**Subject: Vermont Yankee Nuclear Power Station
License No. DPR-28 (Docket No. 50-271)
Technical Specification Proposed Change No. 254
Definition of "Operable"**

Proposed Technical Specification Change No. 254

Marked-up Version of the Current Technical Specifications

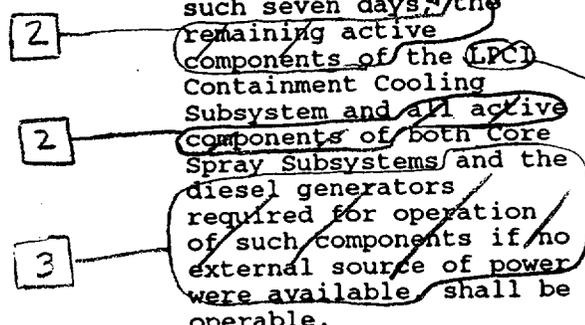
2. From and after the date that one of the Core Spray Subsystems is made or found to be inoperable for any reason, reactor operation is permissible only during the succeeding seven days unless such subsystem is sooner made operable, provided that during such seven days, all active components of the other Core Spray Subsystem, the LPCI Subsystems, and the diesel generators required for operation of such components if no external source of power were available, shall be operable.

3. From and after the date that one of the LPCI pumps is made or found to be inoperable for any reason, reactor operation is permissible only during the succeeding seven days unless such pump is sooner made operable, provided that during such seven days, the remaining active components of the LPCI Containment Cooling Subsystem and all active components of both Core Spray Subsystems and the diesel generators required for operation of such components if no external source of power were available shall be operable.

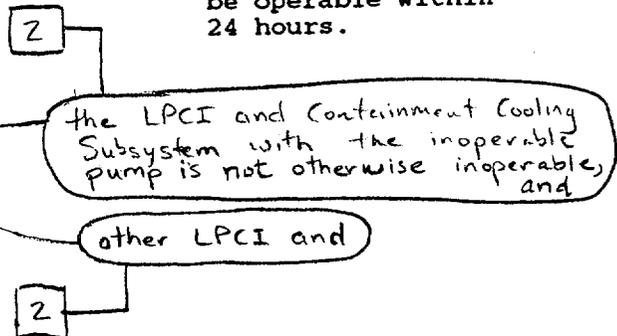
2. When one Core Spray Subsystem is made or found to be inoperable, the active components of the redundant Core Spray Subsystem shall have been or shall be demonstrated to be operable within 24 hours.

3. When one of the LPCI pumps is made or found to be inoperable, the remaining operable LPCI pumps shall have been or shall be demonstrated to be operable within 24 hours.

1. Diesel Generator

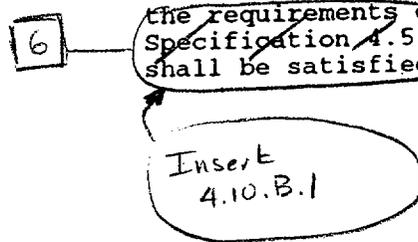
When one of the diesel generators is made or found to be inoperable, the requirements of Specification 4.5.H.1 shall be satisfied.
